DEVELOPMENT REVIEW BOARD SUPPLEMENTAL SUBMITTAL

TO: PROJECT NO. 1004606
 ALL MEMBERS Valle Vista Units 1-2

Re: Valle Vista Unit 1 – Infrastructure List and Sidewalk Deferral/Waiver Exhibit Amendments
(DRB 1004606)

Re: Valle Vista Unit 2 – Infrastructure List and Sidewalk Deferral/Waiver Exhibit Amendments
(DRB 1004606)

EXHIBIT "B"
VALLE VISTA UNIT 1
SIDEWALK DEFERRED/WAIVER EXHIBIT
REVISED 09/10/2014

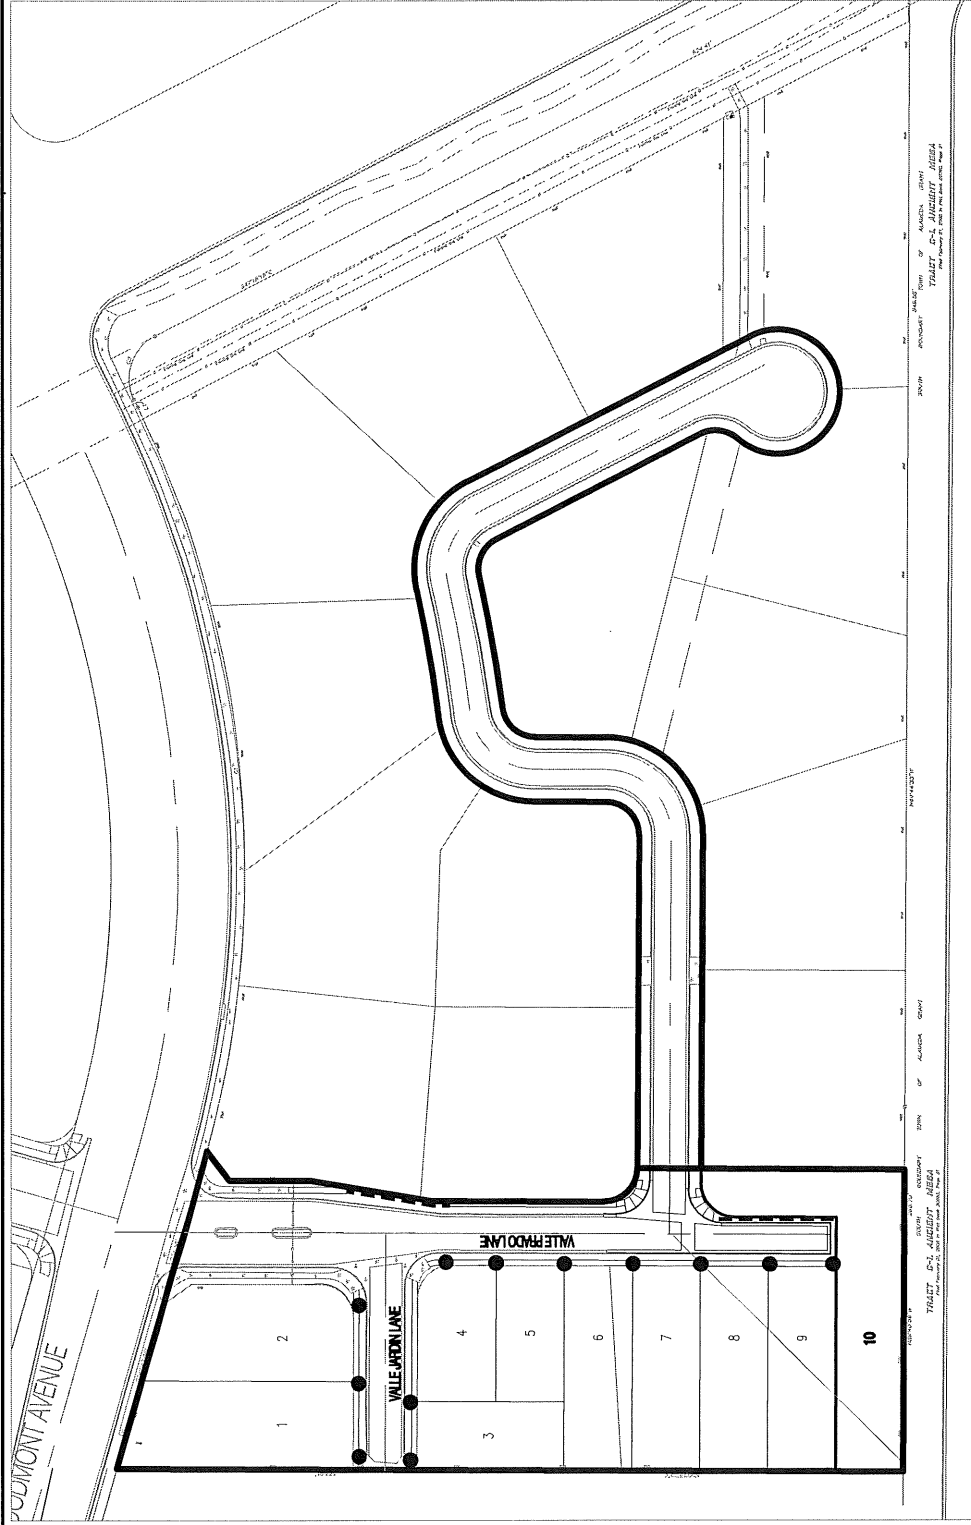
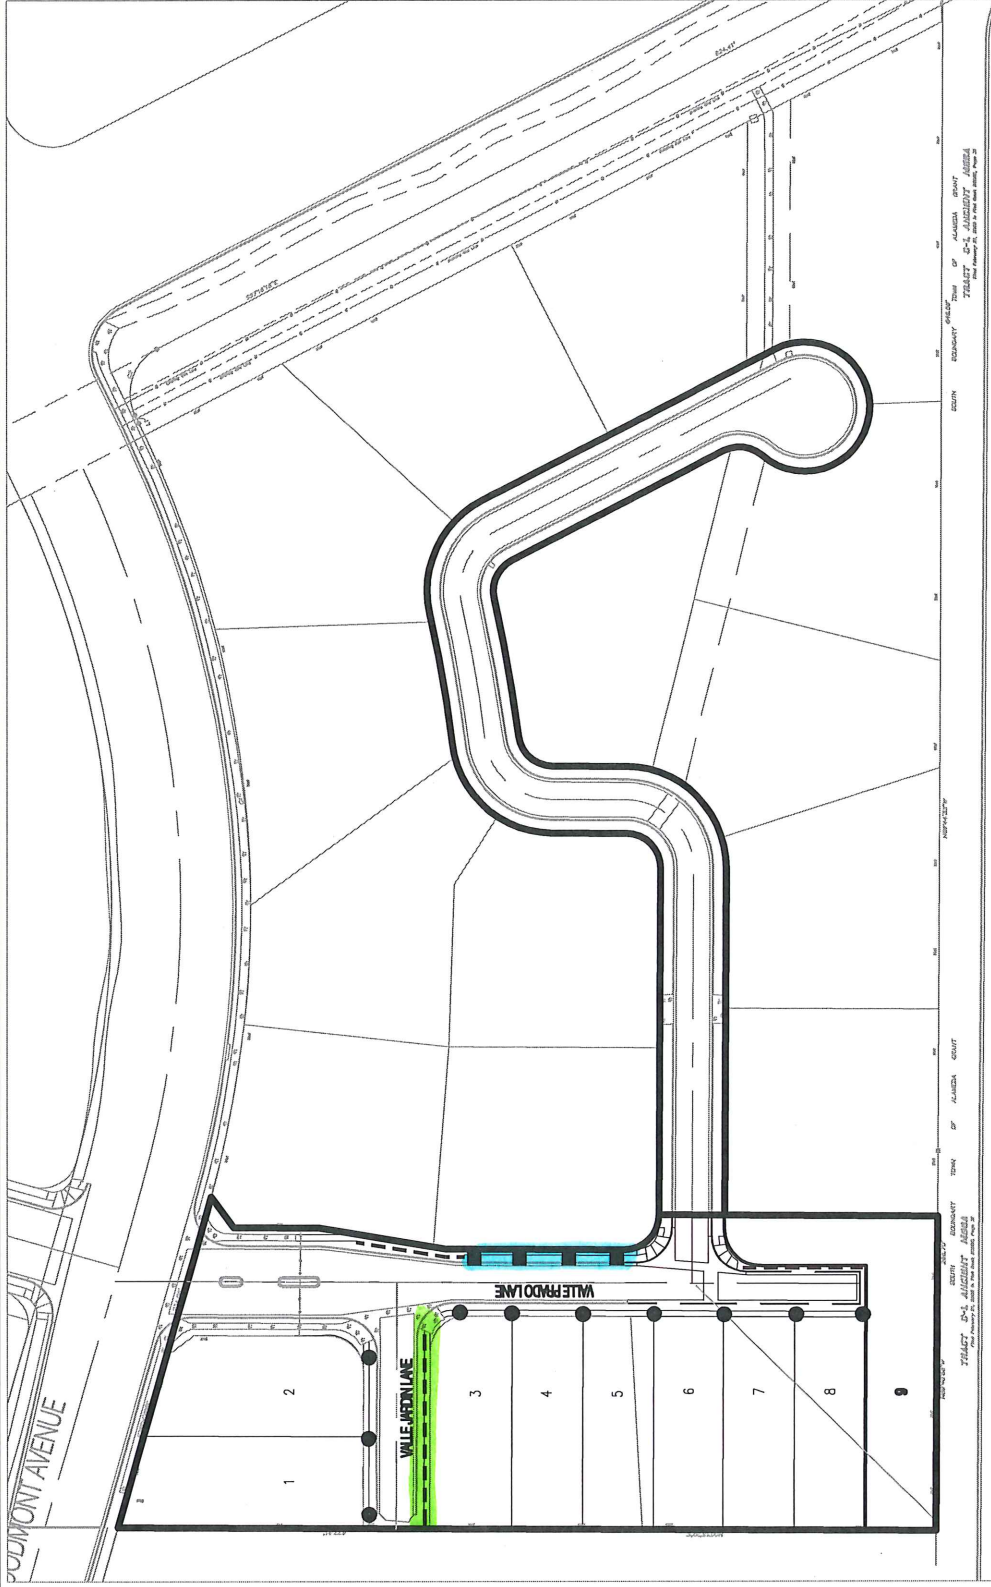
1. Waive the sidewalk on the south side of Valle Jardin Lane from the west boundary to Valle Prado Lane. This section of Valle Jardin Lane will not continue to the subdivision to the west due to limitations for gated subdivisions in the Volcano Trails Sector Plan. Therefore, Valle Jardin will be a stub street with no lots fronting the south side of the street. Waiving sidewalk in this location would not impact pedestrian circulation in the subdivision. This revision is highlighted in green on the revised sidewalk exhibit dated 9/10/14.

2. Defer sidewalk construction from Unit 1 to Unit 2 on the east side of Valle Prado Lane between the future (Unit 2) Valle Jardin Lane and Valle Cantero Lane. The deferral is being requested to reduce damage to sidewalks due to Unit 2 construction. Lot 7, Unit 2 fronts Valle Prado Lane and home construction would damage the sidewalk if it is not deferred to Unit 2 home construction. The Lot 8 Unit 2 side yard wall construction would damage the sidewalk if built with Unit 1. Deferring the sidewalk for this section of Valle Prado Unit 1 does not impact the pedestrian circulation for Unit 1 as there is sidewalk on the west side of Valle Prado Lane to Woodmont Avenue. This revision is highlighted in blue on the revised sidewalk exhibit dated 9/10/14.

■ ■ ■ ■ ■
 DEFER sidewalk to Valle Vista Unit 2. The deferral is requested to reduce damage to sidewalks due to Unit 2 construction activities. Lot 7 Unit 2 fronts Valle Prado Lane. Lot 8 Unit 2 side yard wall construction would damage the sidewalk. Unit 1 lots on the west side of Valle Prado Lane will have access to sidewalk on the west side of Valle Prado Lane to Woodmont Avenue.

SIDEWALK DEFERRAL/WAIVER/VARIANCE EXHIBIT REVISED 09/10/2014

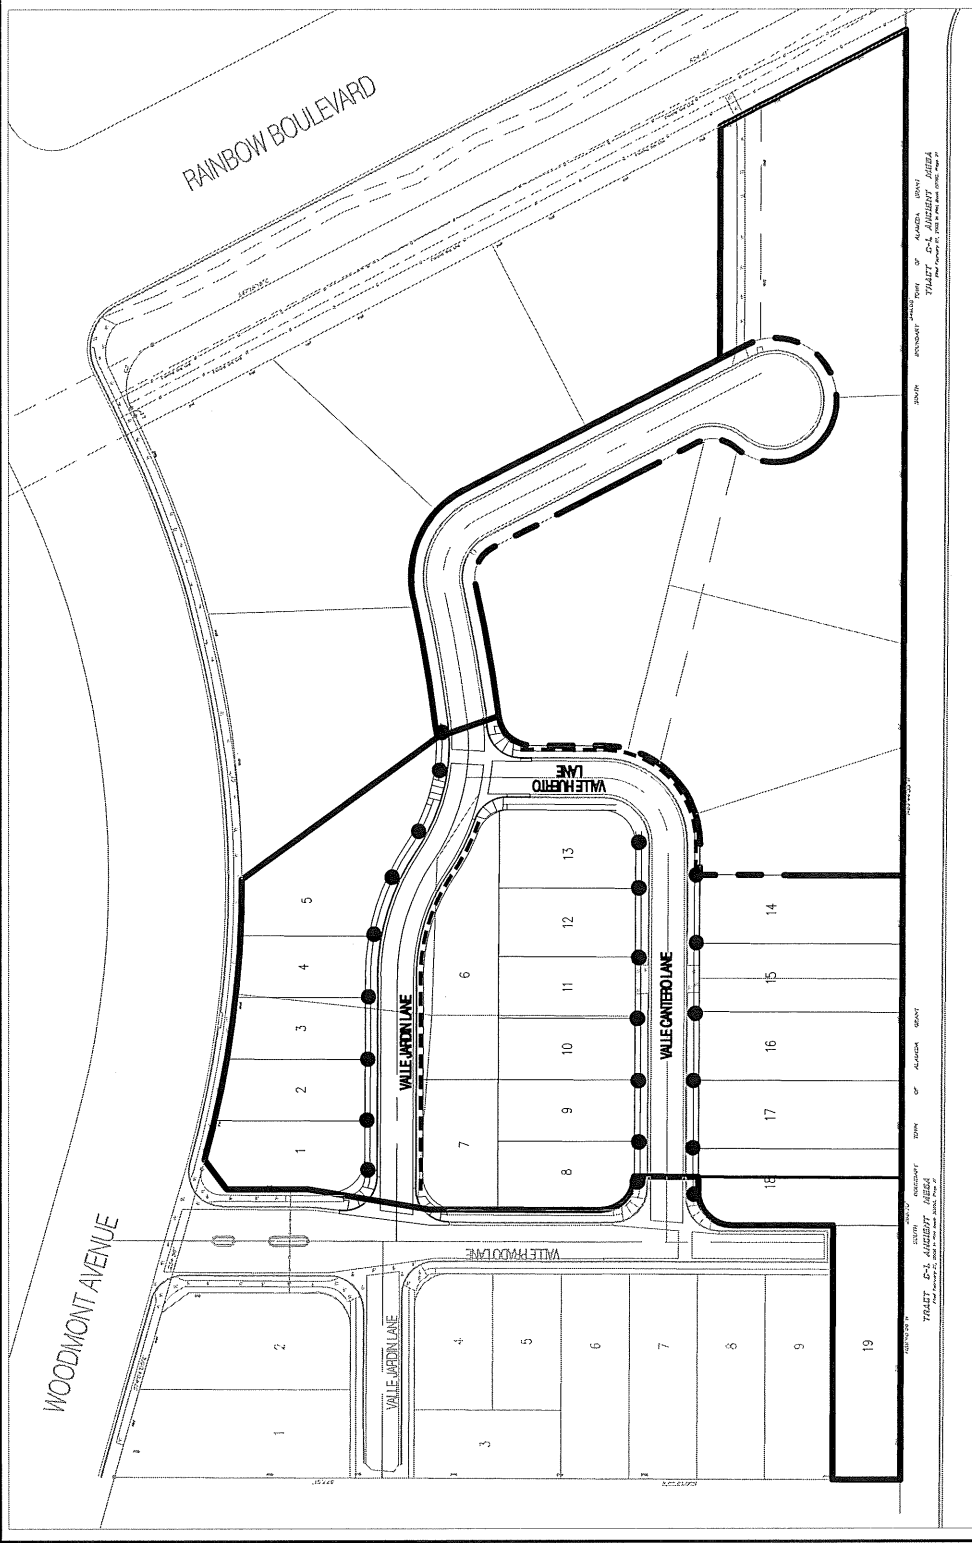
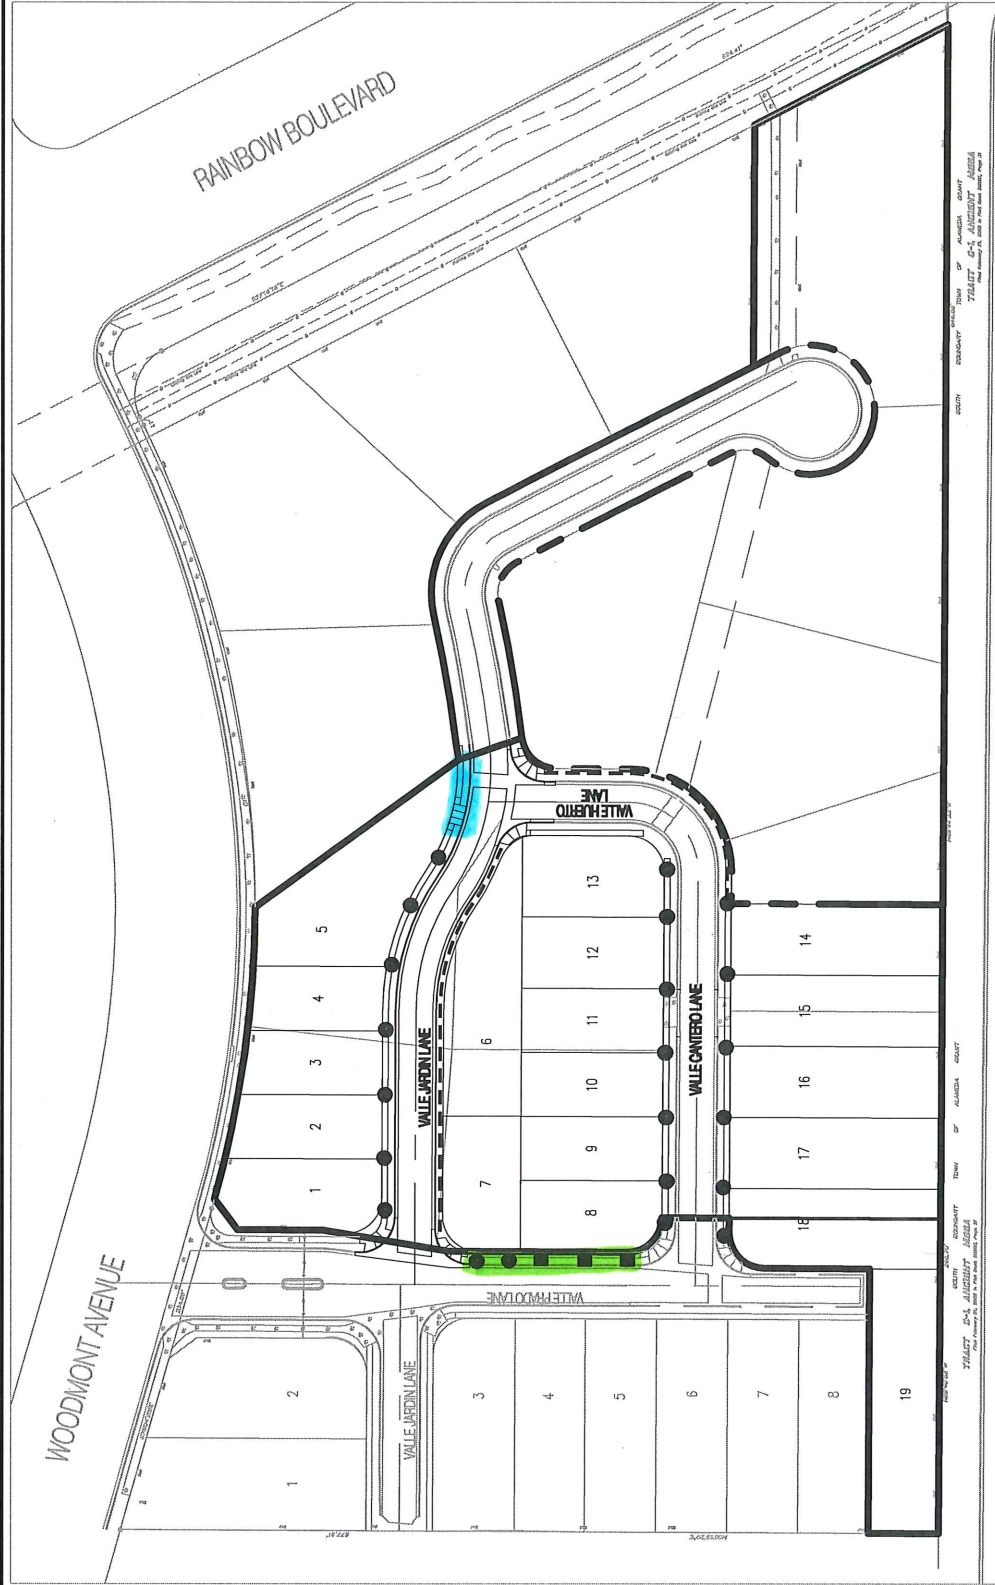
1. Add sidewalk from Unit 1 to Unit 2 on the east side of Valle Prado Lane between Valle Jardin Lane and Valle Cantero Lane. Temporary deferral of sidewalk construction is requested for Lot 7, Unit 2. The sidewalk along the Lot 8 Unit 2 side yard would be constructed with the Unit 2 public work order. This revision is highlighted in green on the revised sidewalk exhibit dated 9/10/14.
2. Remove the sidewalk deferral of the mid-block ramp and sidewalk to the east of the ramp on Lot 5. This revision is highlighted in blue on the revised sidewalk exhibit dated 9/10/14.

Sidewalk deferred from Valle Vista Unit 1, to be built with Valle Vista Unit 2.
